SUNNYSIDE / RANDLES LANE WETLEY ROCKS ST90AT

NON MATERIAL AMENDMENT

TO ENABLE A SAFE AND LEVEL ACCESS

D.W.G 0020

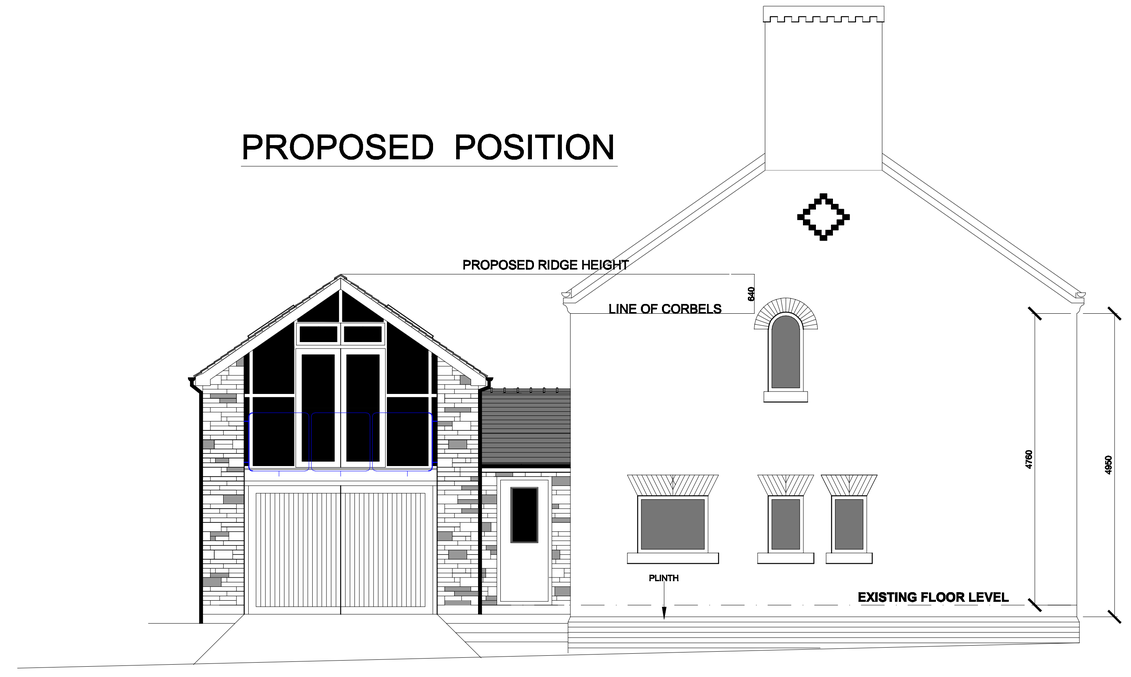
THE PROPOSAL IS TO ENABLE A LEVEL FLOOR LINE CONSISTENT WITH THE EXISTING FLOOR LEVEL OF THE MAIN DWELLING. THE ORIGINAL APPLICATION STEPPED THE FLOOR LEVEL WITH 2 STEPS, A STEP DOWN INTO THE LINK CORRIDOR, AND DOWN AGAIN INTO THE EXTENSION. HOWEVER WHEN LOOKED AT IN A PRACTICAL SENSE THE STEPS WERE UNPRACTICAL AND DANGEROUS.HAVING DRAWN A SECTIONAL PROPOSAL, WITH THE SAME OVERALL VERTICAL DIMENSION AS THE ORIGINAL PLAN IT BECAME CLEAR THAT THE IDEA TO RESTRICT THE ORIGINAL RIDGE HEIGHT BELOW THE EXISTING CORBELS LEFT AN UNREALISTIC DIFFERENCE BETWEEN THE EXISTING FLOOR LEVEL AND THE PROPOSED EXTENSION FLOOR LEVEL A DIFFERENCE OF APPROXIMATELY 840mm DIVIDED BETWEEN 2 STEPS WOULD BE UNACCEPTABLE FROM A BUILDING REGULATION POINT OF VIEW.
